**ANSTY GARDEN COMMUNITY,**

**DESIGNERS RESPONSE**

**REPORT REF NO. 2207280-R18A**

**Road Safety Audit Stage 1**  
**Land at Ansty Farm**  
**Proposed Highway Improvements**  
**London Road / Whitemans Green**  
**Cuckfield**  
**West Sussex**

Drawing Number **2207280-002** Rev **A**

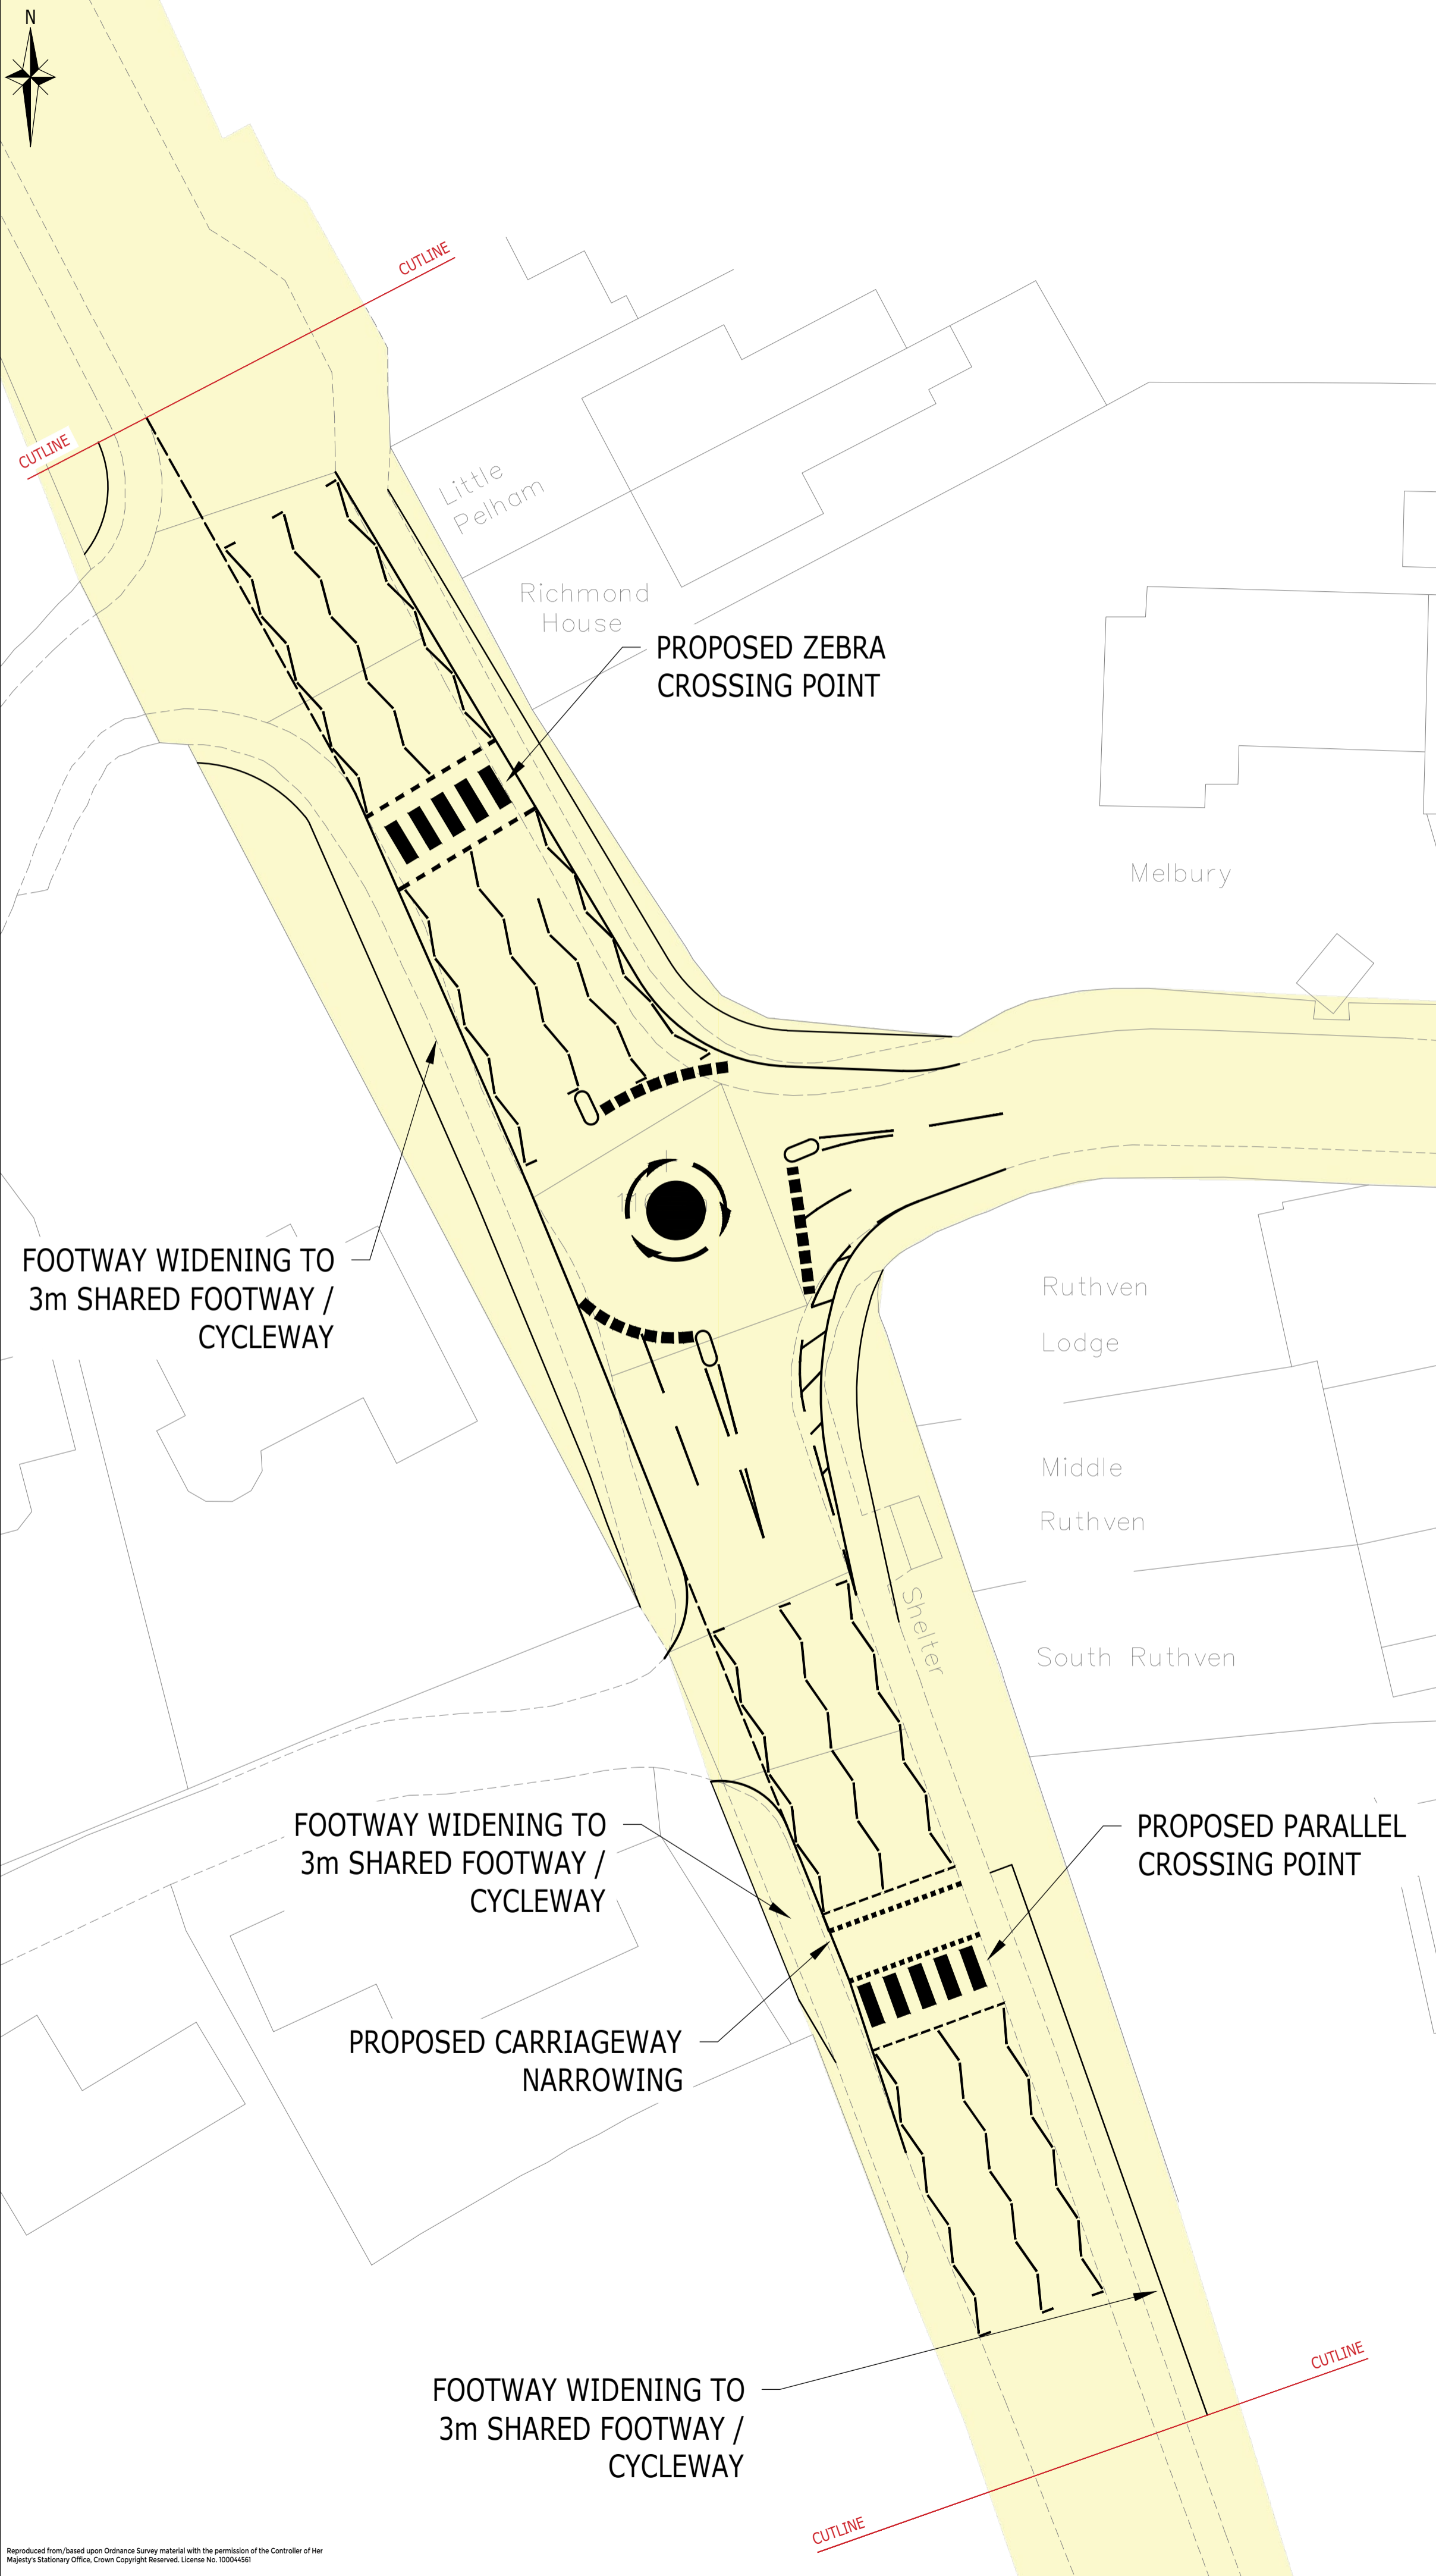
##### **3.1.1 PROBLEM**

**Summary:** Irregular usage of the crossings could lead to vehicle to pedestrian / cyclist collisions or rear end shunts.

From observations on site there appears limited demand for these crossing facilities. Lack of usage of a controlled crossing can lead to drivers continually seeing no one using the crossing, then being surprised when a pedestrian or cyclist uses the crossing. This could lead to vehicle to pedestrian / cyclist collisions, or sudden braking and rear end shunts.

##### **3.1.2 PROBLEM**

The proposals do not include the introduction of anti-skid surfacing or a surface with a high polished stone value (PSV) on the approaches to the crossings. Surfacing with an inadequate PSV could lead to vehicles not being able to stop, leading to possible rear end shunt or vehicle to pedestrian / cyclist collisions.

**Location:** Proposed shared use footway / cycleways.

Shared use footway / cycleways are proposed; however, no details have been supplied on how cyclists will gain access to the on carriageway or if the shared routes continue. It is unlikely that cyclists will dismount, rather they will continue to ride on the footway, which could lead to cyclist to pedestrian collisions.

**Location:** Proposed shared footway / cycleways.

Shared footway / cycleway are proposed; however, at this early stage, no details have been provided on the tactile paving. Pedestrians may be unaware that the footway is a shared use route, which may lead to cyclist to pedestrian collisions.

**Location:** Proposed crossings.

At this early stage, no street lighting is proposed at the crossings, where the existing lighting system appears to be limited and may not be sufficient for the crossings. Pedestrians and cyclists could attempt to cross and suddenly appear from the dark area without, which could lead to vehicle to pedestrian / cyclist collisions.

**Location:** Proposed shared footway / cycleways.

Shared footway / cycleways are proposed; however, at this early stage, no details have been provided on the vertical signage. Pedestrians may be unaware that the footway is a shared use route, which may lead to cyclist to pedestrian collisions.

#### 3.5.3 **PROBLEM**

The Give Way lines appear too close to the stud lines at the Zebra crossing. This may cause vehicles to stop close to the crossing, reducing the intervisibility with pedestrians who are using crossing, particularly child pedestrians, which could lead to pedestrian or rear end shunt accidents.

It is recommended that the 'Give Way' markings should be set back a minimum of 2.5m from the stud lines.

Plan attached showing the locations of the problems identified as part of this audit (location numbers refer to paragraph numbers in the report).

<b>RSA problem</b>	<b>RSA recommendation</b>	<b>Design Organisation response</b>	<b>Overseeing Organisation response</b>	<b>Agreed RSA action</b>
<p>3.1.1 Irregular usage of the crossings could lead to vehicle to pedestrian / cyclist collisions or rear end shunts.</p> <p>From observations on site there appears limited demand for these crossing facilities. Lack of usage of a controlled crossing can lead to drivers continually seeing no one using the crossing, then being surprised when a pedestrian or cyclist uses the crossing. This could lead to vehicle to pedestrian / cyclist collisions, or sudden braking and rear end shunts.</p>	<p>It is recommended that surveys should be undertaken to establish a sufficient degree of usage or future usage, for the proposed crossings. Should there be a lack of usage then alternative crossing facilities should be examined.</p>	<p>Disagree. The proposed crossings have been designed in accordance with relevant guidance and standards to ensure potential pedestrian use of the proposed facilities is clearly visible to other road users.</p> <p>As part of Active Travel Guidance pedestrian and cycle facilities are proposed to encourage other modes of transport in line with WSCC consultation feedback, and are designed in order to encourage increased use compared to current levels.</p> <p>There are also schools in the vicinity and parents/pupils would make use of the facilities, which would result in an increased demand outside of the hours observed</p>	<p>The facilities would provide pedestrian crossing opportunities following the widening of the mini rbt to a 2 lane approach.</p>	<p>No further action at this stage.</p>

by the Audit team during their visit.		
<p>3.1.2 Inappropriate surfacing could lead to vehicle to pedestrian / cyclist collisions or rear end shunts.</p> <p>The proposals do not include the introduction of anti-skid surfacing or a surface with a high polished stone value (PSV) on the approaches to the crossings. Surfacing with an inadequate PSV could lead to vehicles not being able to stop, leading to possible rear end shunt or vehicle to pedestrian / cyclist collisions.</p>	<p>It is recommended that antiskid surfacing or surfacing with a high PSV should be used on the approaches to the crossings.</p>	<p>Agree. Details of PSV values and surfacing materials will be provided for Stage 2 Audit.</p>	<p>High friction surfacing should be provided and details of PSV values to be provided at detailed design stage.</p>	<p>High friction surfacing to be provided and details of PSV values to be provided at detailed design stage.</p>

<p>3.4.1 Lack of connectivity could lead to cyclist to pedestrian collisions.</p> <p>Shared use footway / cycleways are proposed; however, no details have been supplied on how cyclists will gain access to the on carriageway or if the shared routes continue. It is unlikely that cyclists will dismount, rather they will continue to ride on the footway, which could lead to cyclist to pedestrian collisions.</p>	<p>It is recommended that details should be supplied on how the shared use route will tie into the carriageway.</p>	<p>Agree. Proposed cycle 'scoops' and dropped kerbs have been shown on <b>ACE Drawing 2207280-002B</b> with appropriate road markings to guide cyclists to and from the proposed shared foot/cycleway facility. The southern crossing design has been amended to a zebra to refine the connectivity for cyclists and simplify the arrangements. Corduroy paving to warn cyclists of the pedestrian footway have also been shown.</p>	<p>Cycle scoops are provided and will assist northbound cyclists to utilise the facilities. It is acknowledged that southbound cyclists are unlikely to use the provision.</p>	<p>No further action at this stage.</p>

It is also noted on the drawing that appropriate signage will be provided as per LTN 1/20 & TSRGD standards.		
<p>3.4.2 Absence of tactile paving could lead to cyclist to pedestrian collisions.</p> <p>Shared footway / cycleway are proposed; however, at this early stage, no details have been provided on the tactile paving. Pedestrians may be unaware that the footway is a shared use route, which may lead to cyclist to pedestrian collisions.</p>	It is recommended that paving details are provided are provided for assessment at Stage 2 Safety Audit.	Agree. The design proposals have been refined in this location and proposed tactile and corduroy paving have been shown on <b>ACE Drawing 2207280-002B</b> . Further details will also be provided for Stage 2 Audit.	Tactile paving details have been shown on the revised plan and will be included in the stage 2 audit.	Suitable tactile paving to be retained within the design and presented for RSA2.

<p>3.5.1 A lack of luminance could lead to vehicle to pedestrian / cyclist collisions.</p> <p>At this early stage, no street lighting is proposed at the crossings, where the existing lighting system appears to be limited and may not be sufficient for the crossings. Pedestrians and cyclists could attempt to cross and suddenly appear from the dark area without, which could lead to vehicle to pedestrian / cyclist collisions.</p>	It is recommended that there should be adequate levels of luminance where a check should be undertaken with Highway Authority Street Lighting Team.	Agree. It has been noted on <b>ACE Drawing 2207280-002B</b> that street lighting is to be considered in liaison with WSCC as per the recommendation. Lighting details to be provided for Stage 2 Audit.	Street lighting details to be provided a detailed design.	Details of street lighting to be provided at detailed design.

<p>3.5.2 Absence of vertical cyclist signage could lead to cyclist to pedestrian collisions.</p> <p>Shared footway / cycleways are proposed; however, at this early stage, no details have been provided on the vertical signage. Pedestrians may be unaware that the footway is a shared use route, which may lead to cyclist to pedestrian collisions.</p>	<p>It is recommended that signing details are provided for assessment at Stage 2 Safety Audit.</p>	<p>Agree. Signage details will be provided for Stage 2 Audit.</p>	<p>Signage details to be provided at detailed design.</p>	<p>Signage details will be provided for Stage 2 Audit.</p>
<p>3.5.3 Positioning of Give Way lines could lead to vehicle to pedestrian collisions.</p> <p>The Give Way lines appear too close to the stud lines at the Zebra crossing. This may cause vehicles to stop close to the crossing, reducing the intervisibility with pedestrians who are using crossing, particularly child pedestrians, which could lead to pedestrian or rear end shunt accidents</p>	<p>It is recommended that the 'Give Way' markings should be set back a minimum of 2.5m from the stud lines.</p>	<p>Agree. The proposed road markings for the zebra crossings have been updated as per safety audit recommendations and TSRGD standards. These are shown on <b>ACE Drawing 2207280-002B</b>.</p>	<p>Give way markings have been updated in the drawing.</p>	<p>No further action at this stage.</p>
